FUJIMOTO et al.
Application No. 10/705,963
August 3, 2006

AMENDMENTS TO THE DRAWINGS

REMARKS/ARGUMENTS

FIG. 1

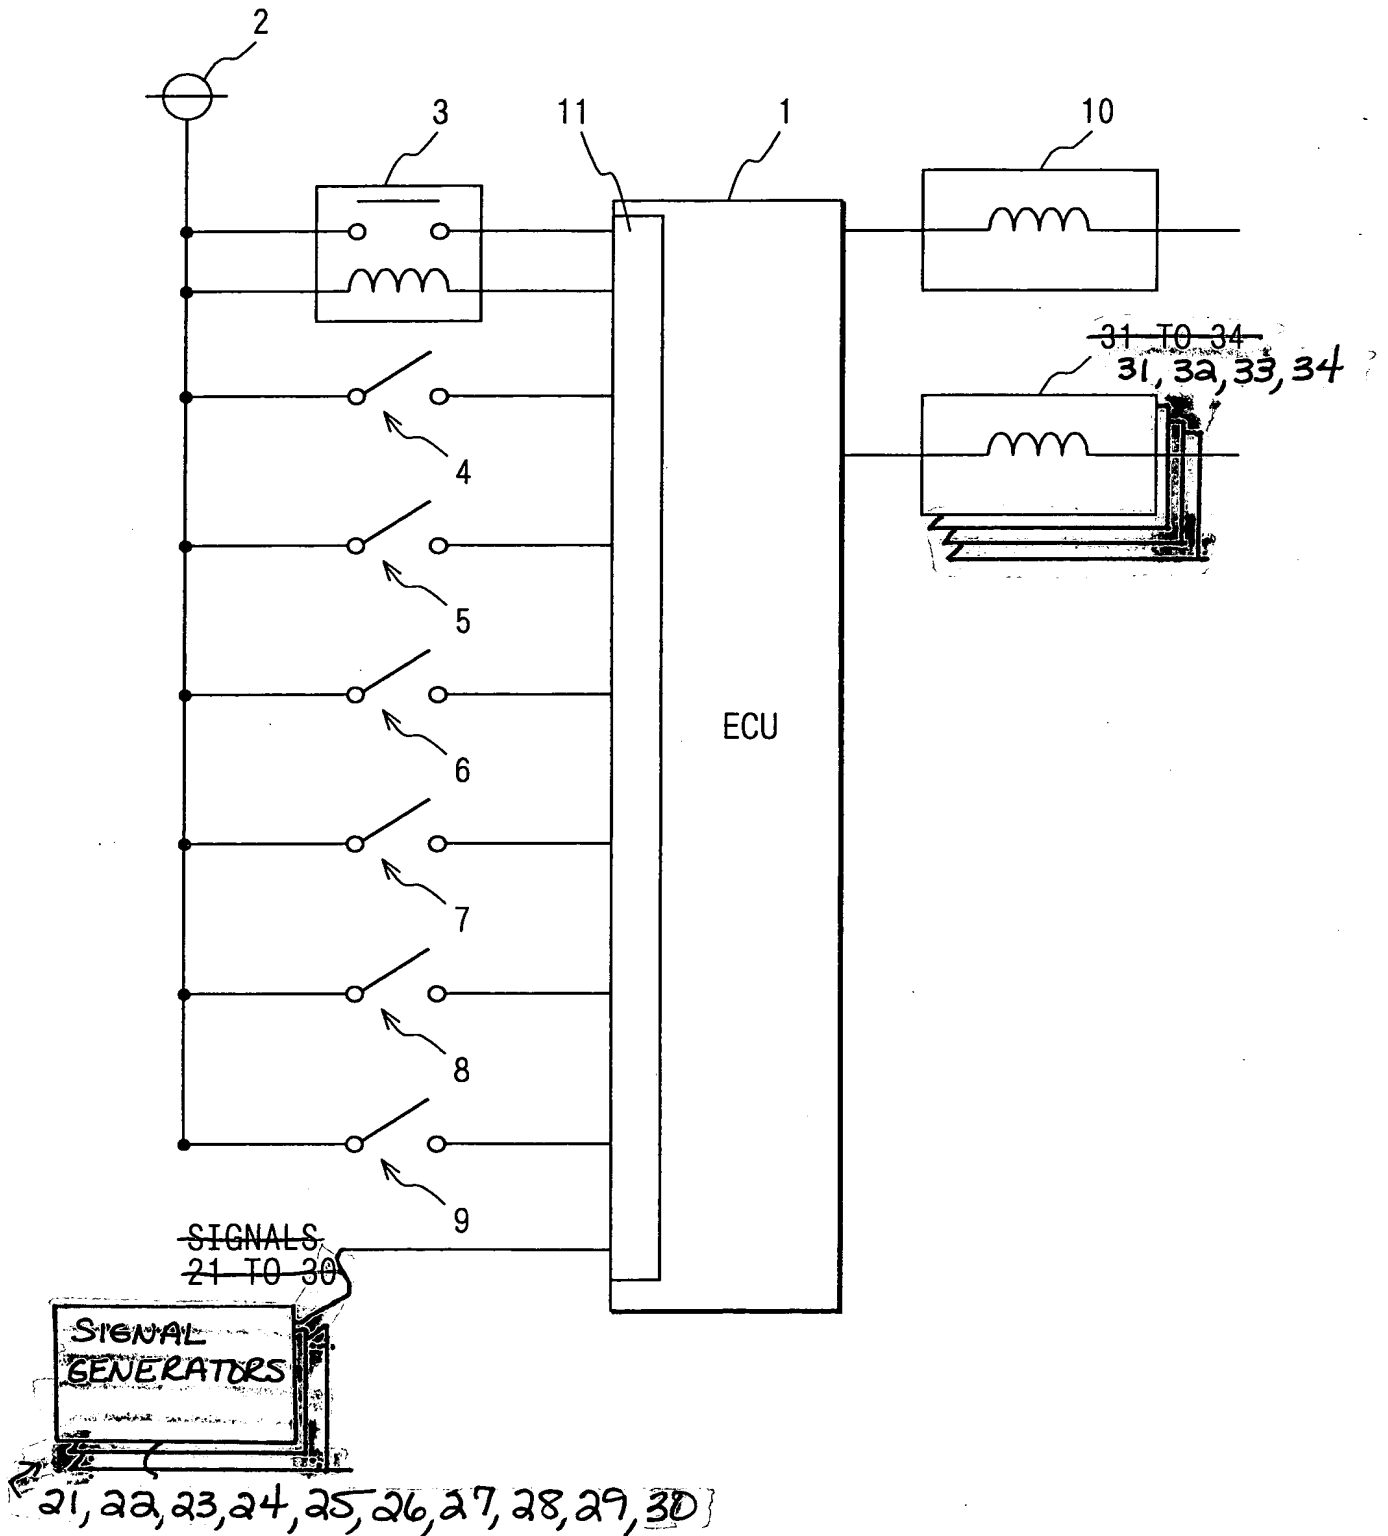
The attached sheets of drawings include changes to Figs. 1 and 6. These sheets, which include Figs. 1 and 6, replace the original sheets including these figures. In Fig. 1, clarification has been provided to signal generators 21-30 and heaters 31-34. In Fig. 6, labels “Yes” and “No” have been interchanged.

Amendments to switches 21-30 in Fig. 1 and heaters 31-34 have been provided to Fig. 1. Applicant therefore respectfully requests that the objection to the drawings be withdrawn.
